ARAMCO RESEARCH CENTER JSP22-19

Consideration at the request of Aramco Americas, for Preliminary Site Plan approval. The subject property is located in Section 4, east of Hudson Drive and north of West Road, and is zoned I-1, Light Industrial. The applicant is proposing to install outdoor storage tanks with liquid hydrogen and natural gas in the existing parking area on the south side of the building.

PLANNING REVIEW

Review Date: May 24, 2022
Review Type: Preliminary Site Plan
Project Name: **JSP 22-19: ARAMCO TANK ENCLOSURE**
Location: 22-04-378-034; 46535 Peary Ct
Plan Date: May 3, 2022
Prepared by: Lindsay Bell, AICP, Senior Planner
E-mail: lbell@cityofnovi.org; **Phone:** (248) 347-0484

Sheet Number	M-102	Rev. No.	
--------------	--------------	----------	--

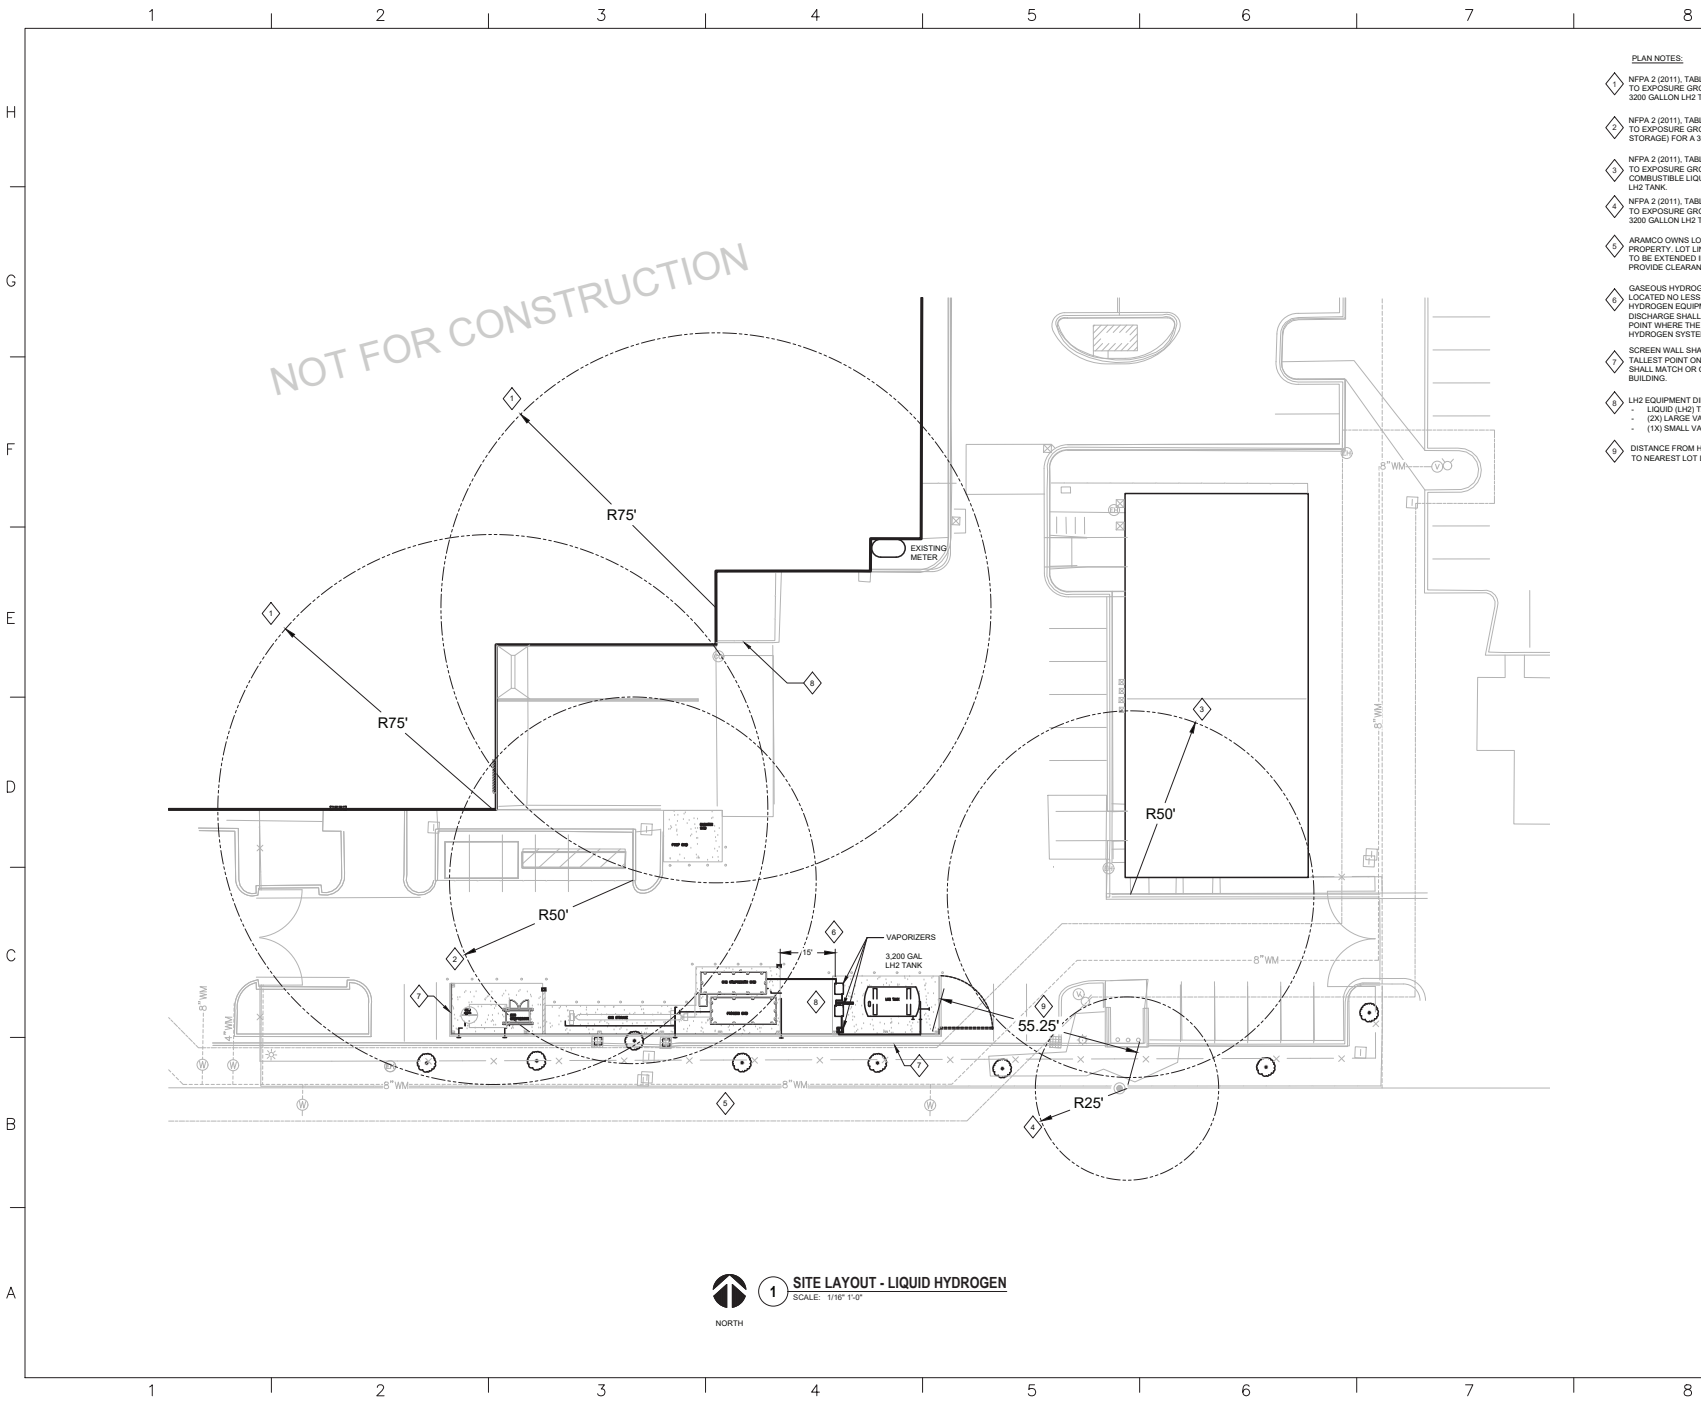
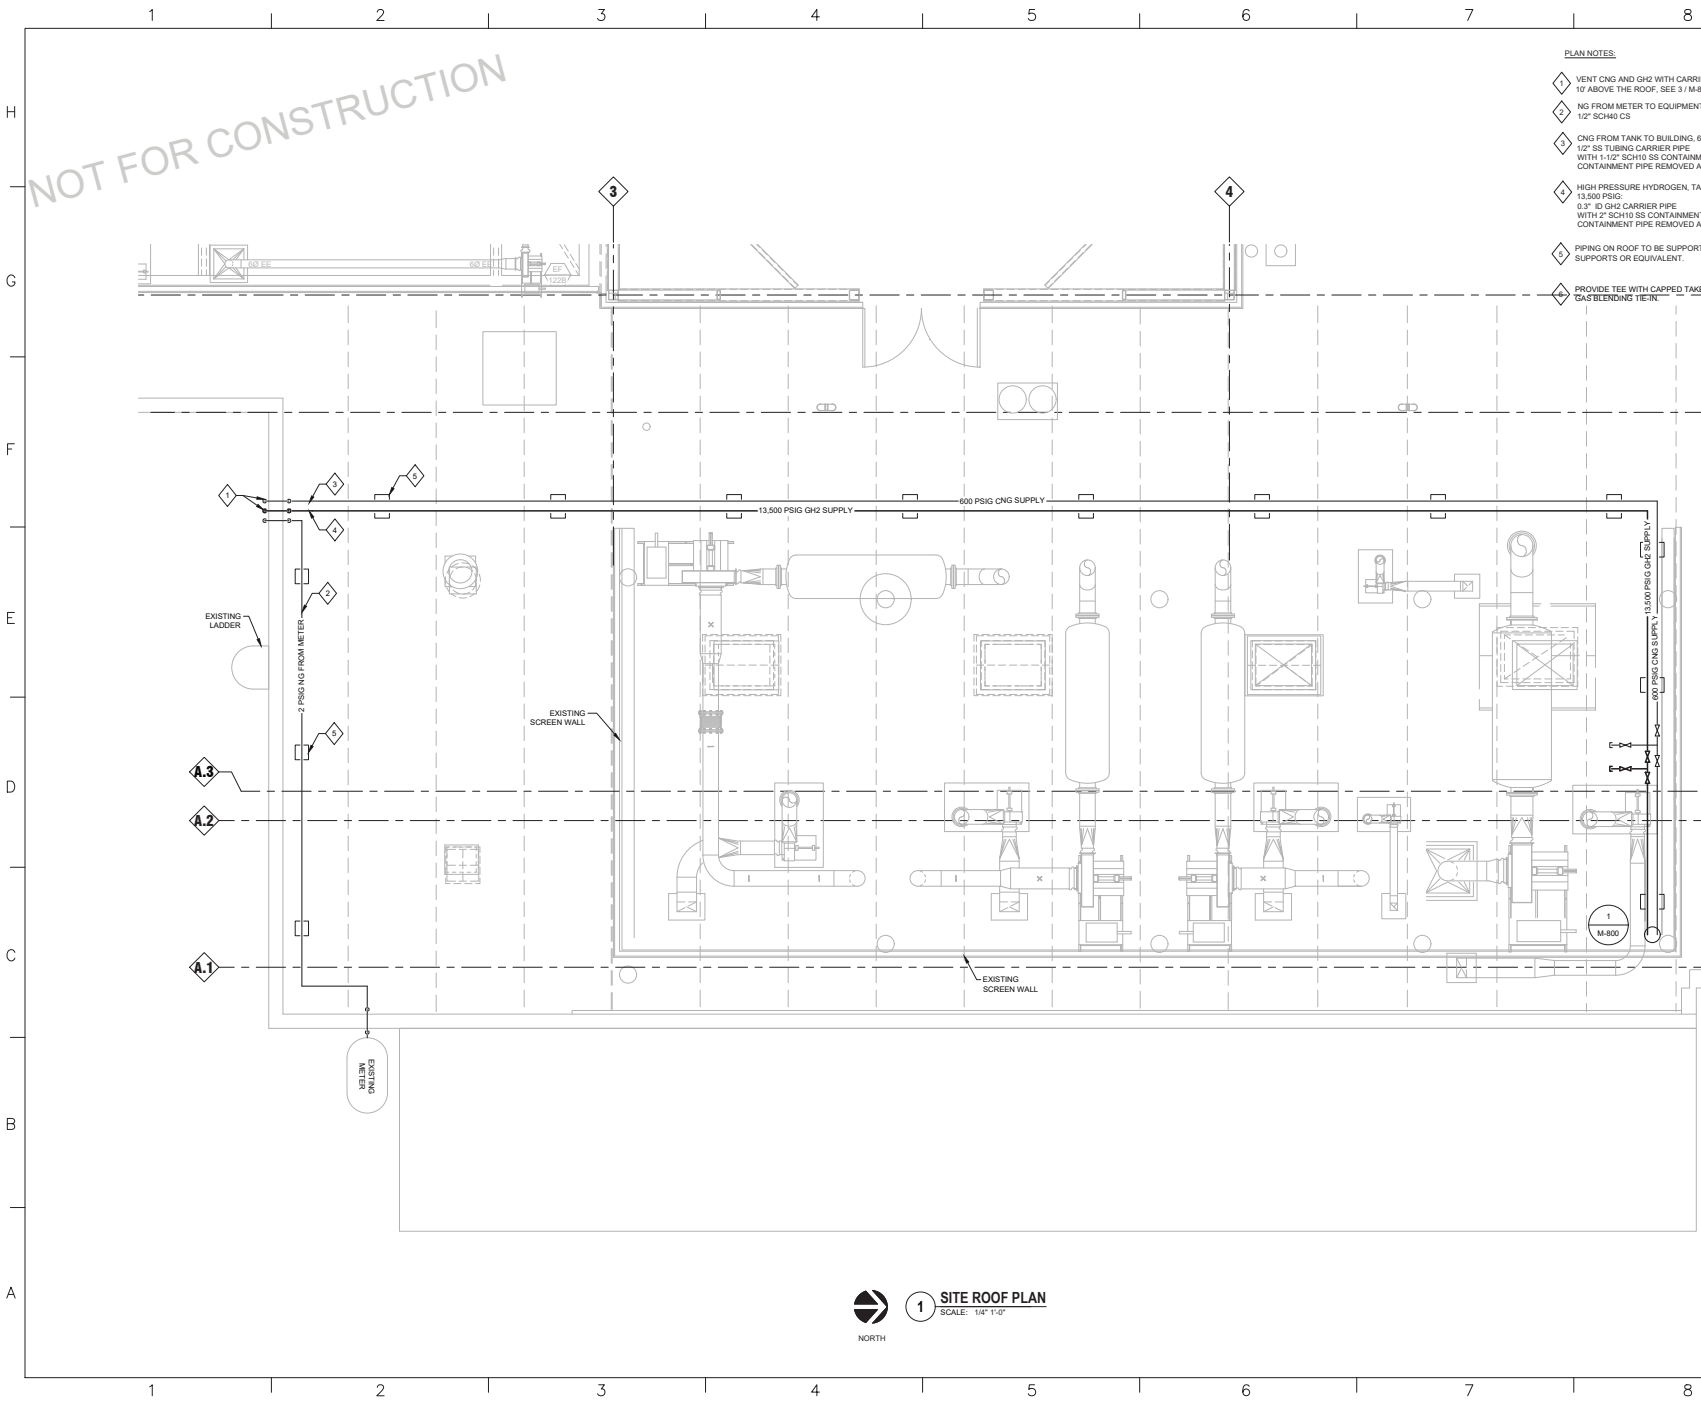
- Shall provide emergency shut off valves. **(NFPA 2 10.3.1.18.4 & 10.3.1.18.5.2).**
- All electrical equipment shall be bonded and grounded per NFPA 70. **(NFPA2 8.3.1.2.7).**
- Shall provide at least 2, 20BC fire extinguishers (Spacing <50). **(NFPA 2 10.3.1.19). On plan #A-201 shows 10lb ABC.**
- Shall provide gas detection for possible leaks. **(NFPA 2 10.3.1.19.1).**
- Shall provide documentation or have fire department witness a leak test on piping. **(NFPA 2 10.3.1.10.1).**
- Shall provide "WARNING" signs: NO SMOKING, FLAMMABLE GAS. **(NFPA 2 10.3.2.2.1.12).**
- Shall provide Secondary containment for LH2. **(NFPA 2 8.3.2.4.4.1).**
- **Approved 5/17/2022 KSP:** Shall show lot line on plans for distance to tanks.
- Shall document on site plans the above comments.

- Shall provide Secondary containment for LH2. (NFPA 2 8.3.2.4.4.1).
Design Team Response: NFPA 2 (2011), section 8.3.2.1.2 prohibits the use of diking around stationary liquid hydrogen storage containers for the purpose of containing a liquid hydrogen spill. However, measures will be taken in accordance with section 8.3.2.4.4.1 to ensure liquid hydrogen does not flow into drains, storm sewers, or other sensitive locations in the event of a spill.

Design Team Response: The proposed design includes a 3500-gallon liquid hydrogen tank. Per NFPA 2 (2011), Table 8.3.2.2.1.4, liquid hydrogen systems storing more than 600 gallons shall be installed outdoors.

- Shall provide emergency shut off valves. (NFPA 2 10.3.1.18.4 & 10.3.1.18.5.2).
Design Team Response: NFPA 2 (2011), section 10 is directed towards vehicle fueling and dispensing facilities. We will not be dispensing hydrogen into vehicles. An emergency shutoff valve will still be provided in the hydrogen supply piping to the building both at the equipment pad and immediately before entering the building as a "best practice" safety measure.
